SKF Technical Bulletin

VKJC 1045/1046/5205/5208 – Mandatory Stub-shaft kit replacement combined with driveshaft kit

VW Multivan V, Transporter V

Pic. 1

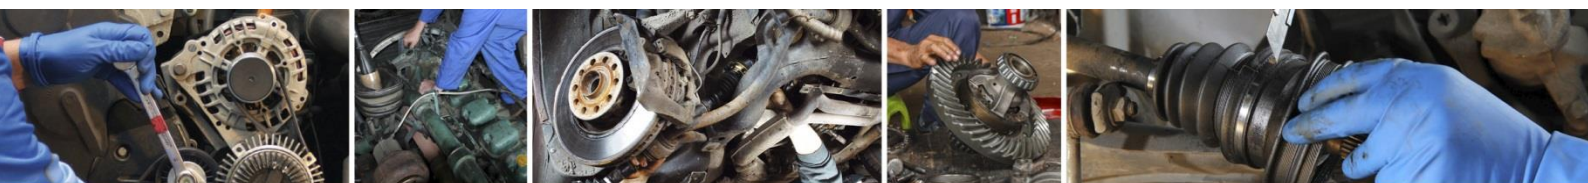
Due to vehicle transmission dysfunctions on the above applications, there are issues with the original gearbox side tooting the driveshaft which leads to premature stub-shaft and driveshaft failure, as shown below on Pic 1 and Pic. 2.

The problem will persist if the driveshaft is replaced without a new stub shaft. Indeed, the tooting of the original stub shaft will present more tolerance than required, so it will prematurely damage the driveshaft tooting.

Therefore, for a complete and professional repair, SKF is offering both components as this is mandatory to replace the driveshaft and the stub-shaft at the same time.
